Office Action Summary

10/527,306

BAR ET AL.

DETAILED ACTION

Fig. 5

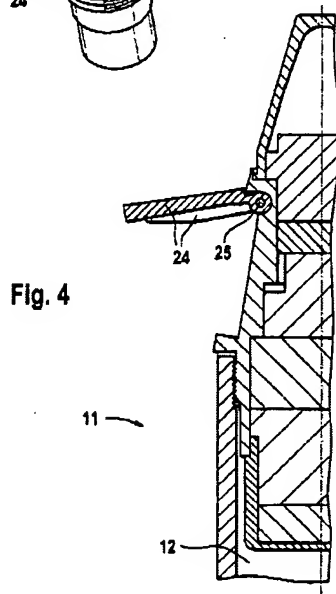
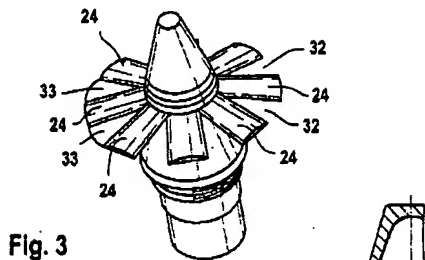
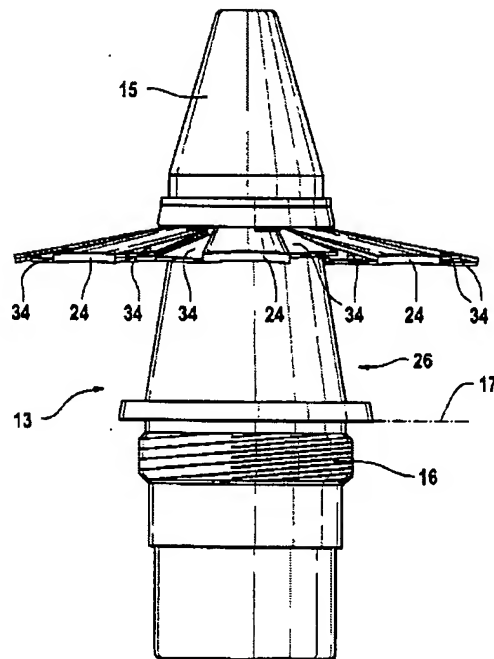
Bar et al. clearly disclose the invention substantially as claimed (see abstract, Figs. 2-5 and at least col. 5, lines 34-54; "For the reasons already referred to in the opening part of this specification, it is inevitable that the braking device comprising the extended, **relatively narrow individual sectors 24** of the annular disc, forms gaps in a spoke-like configuration. In order to close the openings 32 formed by those gaps (FIG. 3) in order to enhance the braking action, it is possible to provide between each two mutually adjacent sectors 24 a flexible bridging portion 33 which is stretched out in the course of extension of the sectors 24, as shown at the left in FIG. 3. That bridging portion 33 between the sectors forming the annular braking disc can comprise for example **textile fabric** which, in the inwardly folded condition of the sectors 24, is folded in radially under them. The sectors 24 can then even be thinned down to the form of narrow radial spokes, the suspension of which on short pins 25 gives rise to fewer structural problems than the flap suspension of the wider sectors 24, and which in the extended condition afford a stiffening effect, which is structurally defined in an umbrella-like manner, for the braking device which is then generally of a textile nature in the form of an annular disc.

Figs. 3-5 depict the textile natured gapless brake 24, 33 unfolded in an obtuse-angled frusto-conical shape.

7. Applicant's arguments filed 5/7/2007 have been fully considered but they are not persuasive. The examiner contends that the Bar '016 does in fact disclose a gapless peripherally extending braking screen as illustrated in Figs. 3-5, which depict the textile natured gapless brake 24, 33 unfolded in an obtuse-angled frusto-conical shape.

There is nothing in the '016 disclosure that proves that the brake 24, 33 is flat or assumes an operative position perpendicular or normal to the longitudinal axis of the projectile rather than as shown in Figs. 3-5 above.
